NOTICE OF APPROVAL

Planning Case #: Design Study 23185

Project Description: Reduce existing eaves throughout, remove the east brow roof, lower roof line, partially remove the south rake and wood lintel over the entryway on the east façade, demo exterior crawl space access well, add two (2) corbels to support south rake of primary suite and wood shutters at upstairs east windows, site coverage and new landscape work, and install a 24 kw gas backup generator in "Zombiebox" in the south yard

Permit #: DS 23-185 (Homrig) (revised DS 22-029 (Homrig)

PROPOSED ELEVATION - SOUTH

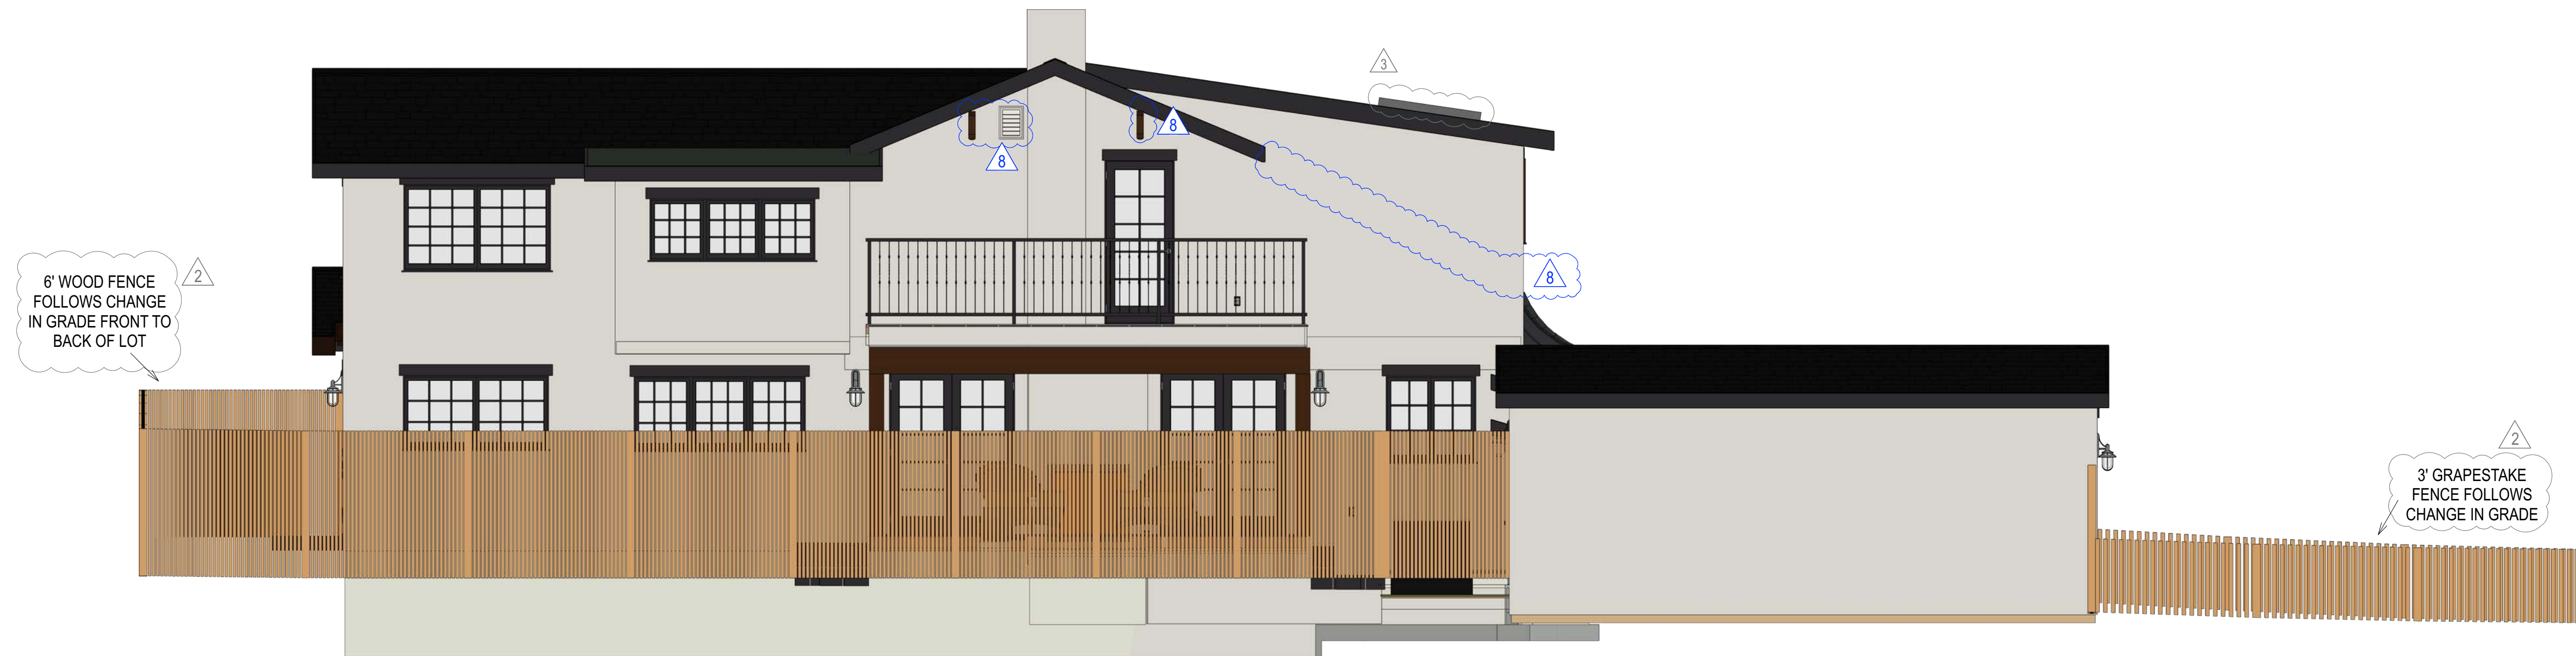
CHANGE ORDER #3 SCOPE OF ELEVATION CHANGES
EAVES REDUCED TO 12" OR 16" THROUGHOUT
REMOVE EAST BROW ROOF, PARTIALLY REMOVE SOUTH RAKE
TWO CORBELS TO SUPPORT SOUTH RAKE OF PRIMARY SUITE LOWER
ROOFLINE
WOOD ATTIC VENT, STAINED TO MATCH FRONT DOOR

CUT BACK ALL EAVES & RAKES, EXCEPTING
GARAGE AND NORTH & SOUTH RAKES OF EAST
FACING SECOND FLOOR SHED ROOF ON
PRIMARY SUITE. SEE DETAILS ON SHEET A-6.3
FOR EAVE & RAKE DEPTHS.
LOWER BROW ROOF ON EAST FACADE
REMOVED

EAVE: PRIMARY SUITE

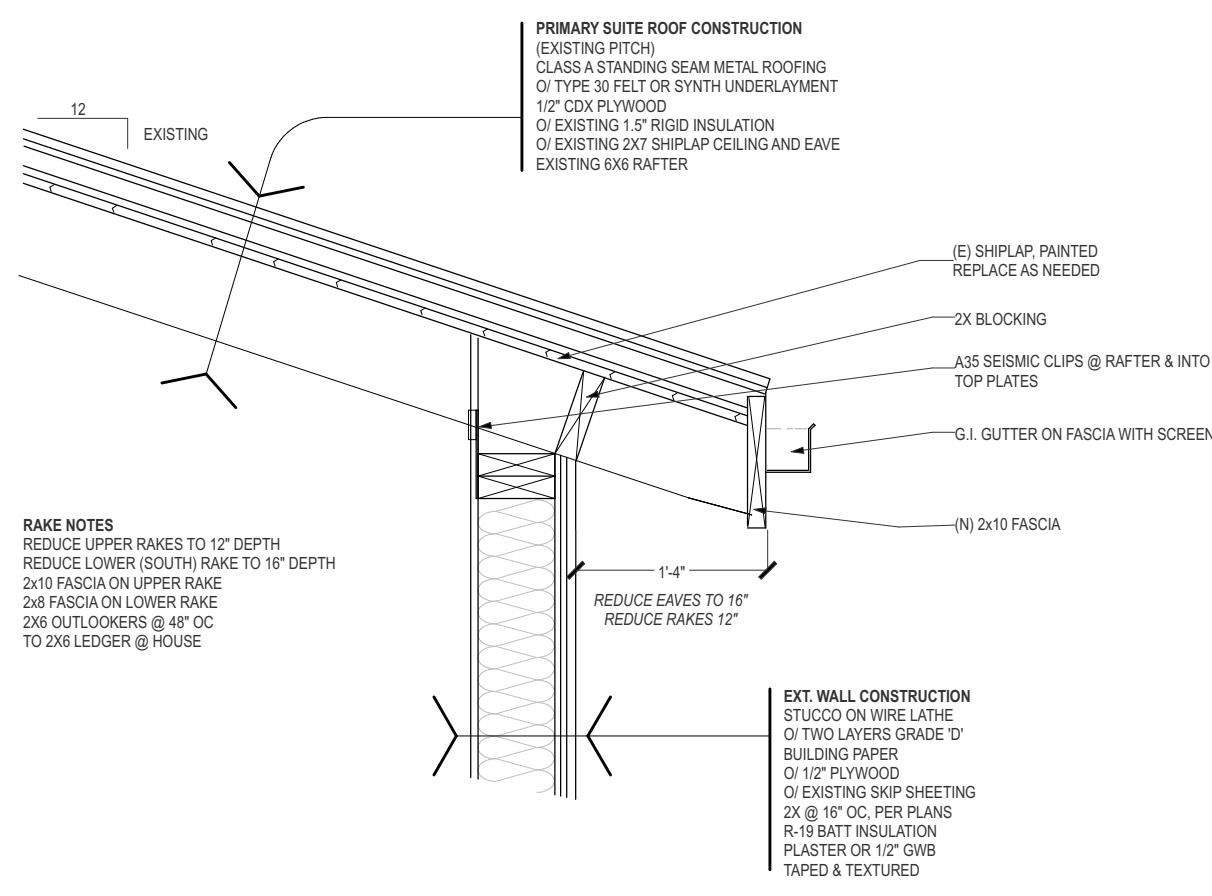
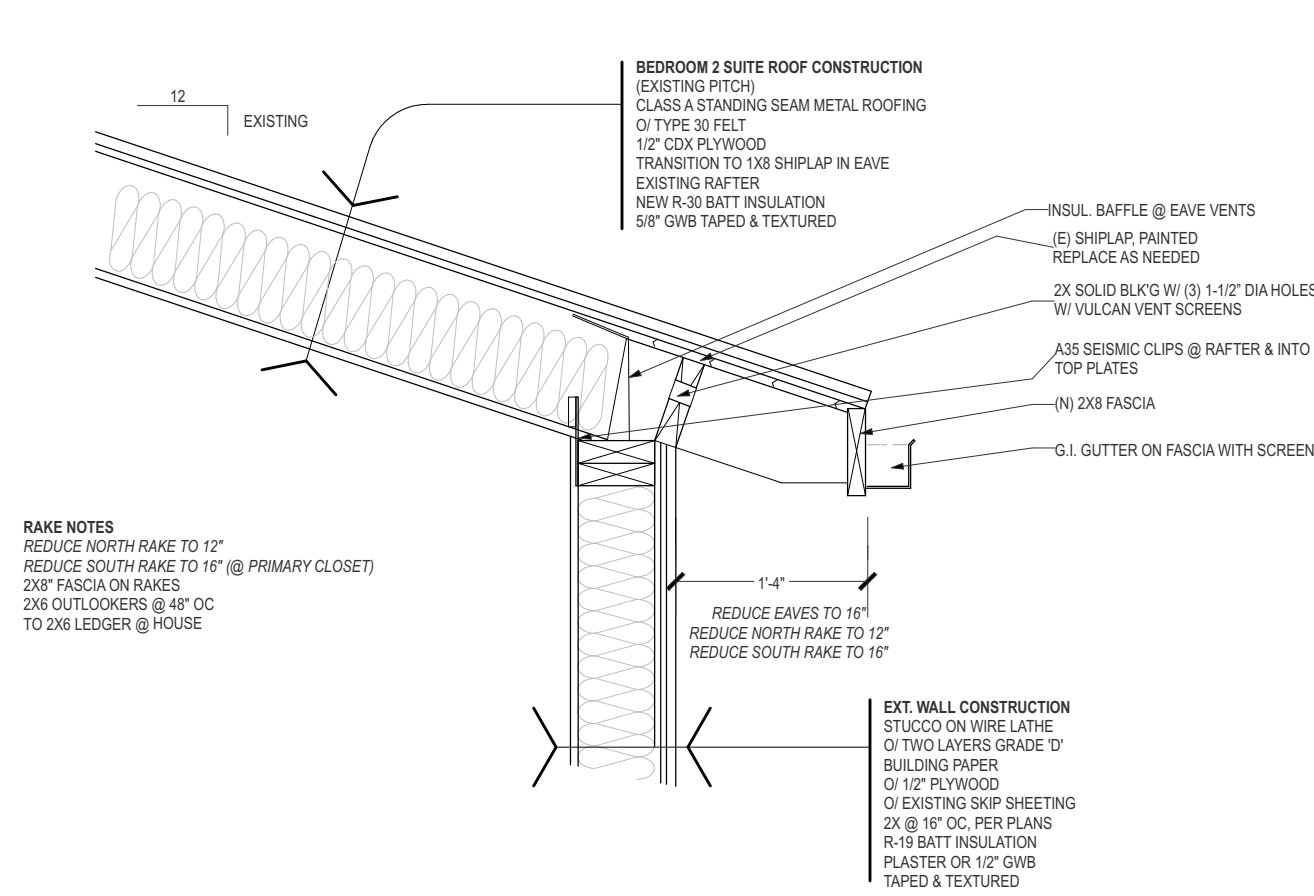
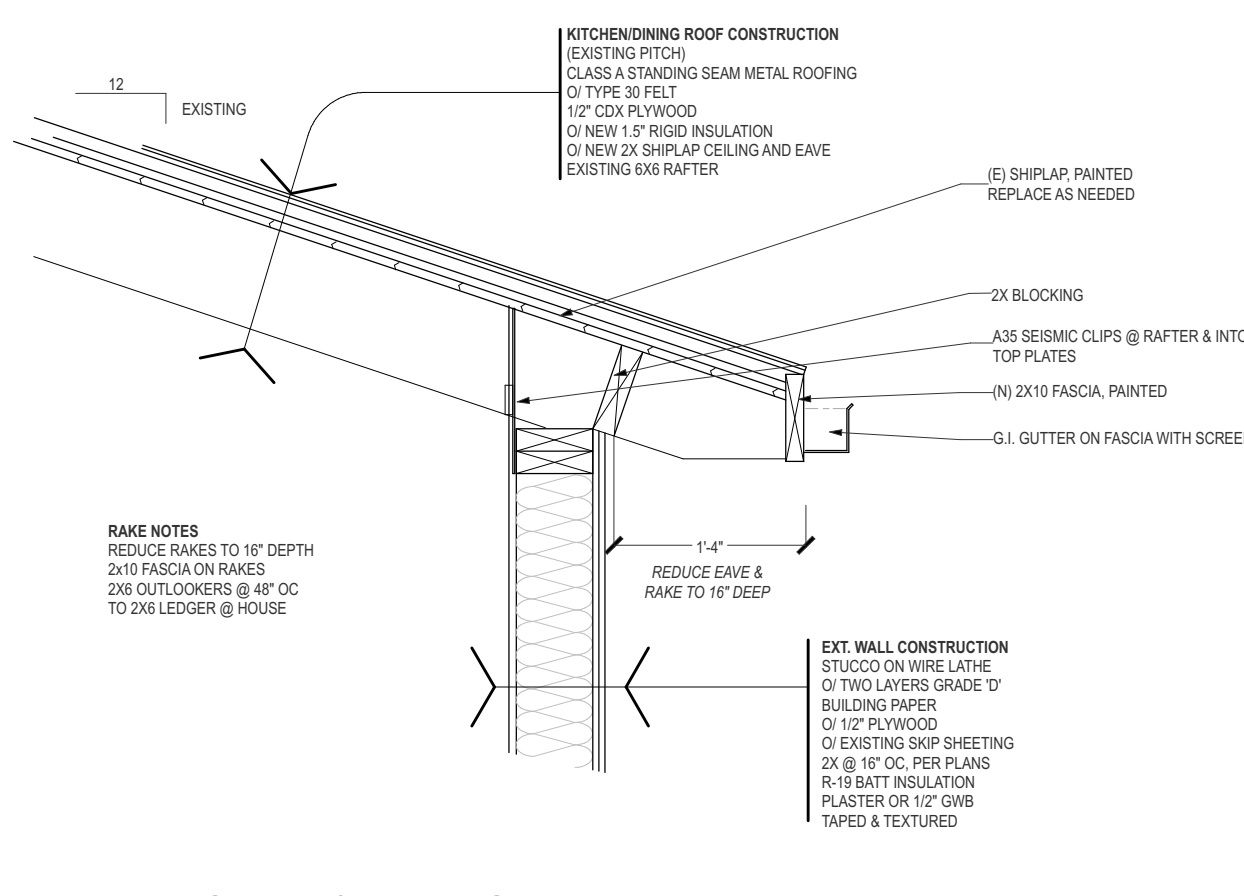
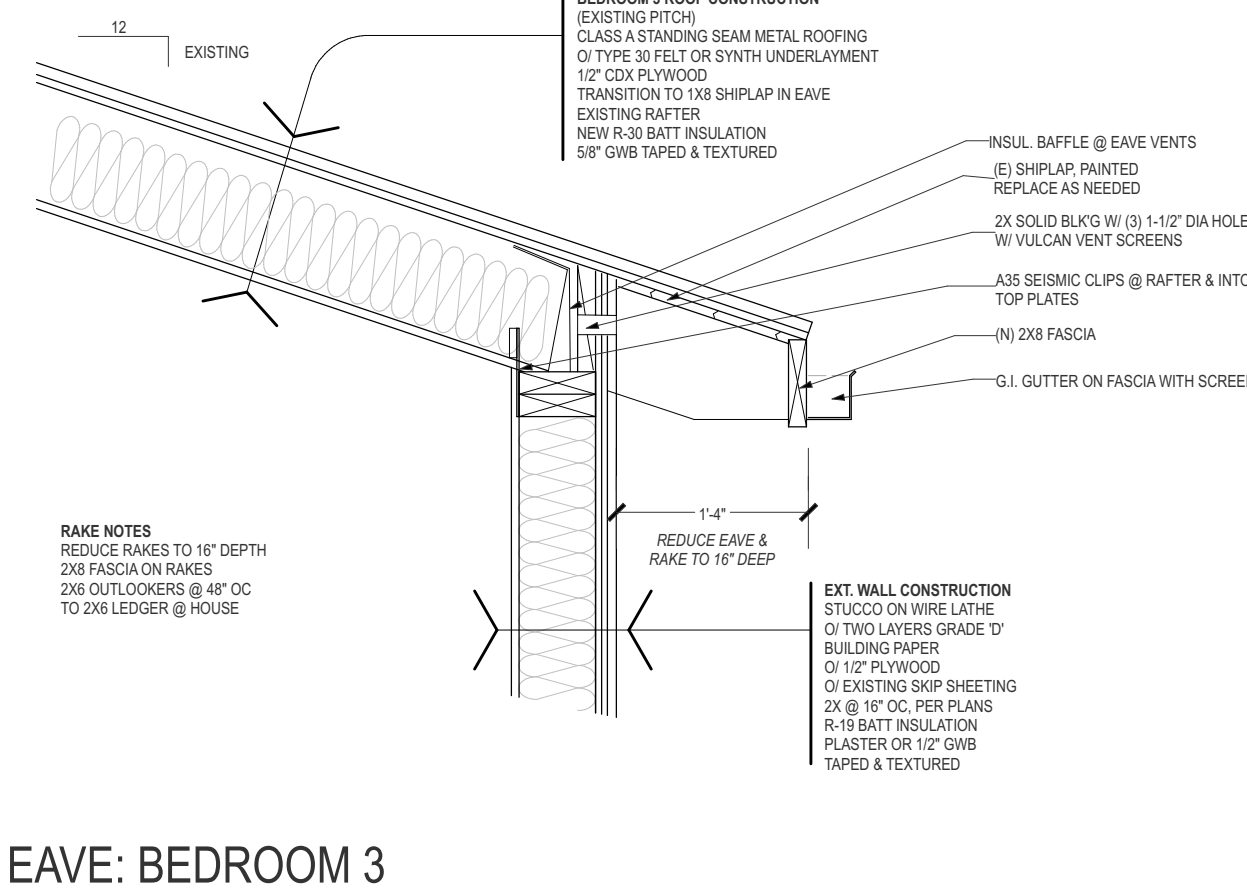
CHANGE ORDER #3
EAVES REDUCED TO 12" OR 16" THROUGHOUT
REMOVE EAST BROW ROOF, PARTIALLY REMOVE SOUTH RAKE WOOD LINTEL OVER ENTRYWAY ON EAST FACADE
TWO CORBELS TO SUPPORT SOUTH RAKE OF PRIMARY SUITE LOWER ROOFLINE
SITE COVERAGE UPDATED TO REFLECT NEW LANDSCAPE PLAN
DEMO EXTERIOR CRAWL SPACE ACCESS WELL. CRAWL ACCESS ESTABLISHED IN BASEMENT
INCLUSION OF LANDSCAPE PLAN
24KW GAS GENERAC BACK UP GENERATOR & IN ZOMBIEBOX SOUND REDUCTION ENCLOSURE IN SOUTH YARD
WOOD SHUTTERS ON UPSTAIRS EAST WINDOWS, STAINED TO MATCH FRONT DOOR
FOUNDATION VENTING CALCULATION ADDED TO BASEMENT PLAN
GABLE ATTIC VENTING ADDED TO RCP & ELEVATIONS
SOUTH EXTERIOR LIGHT AT DINING FRENCH DOOR IS ON APPROVED ELECTRICAL PLAN, WAS MISSING ON FLOOR & SITE PLANS & WEST ELEVATION
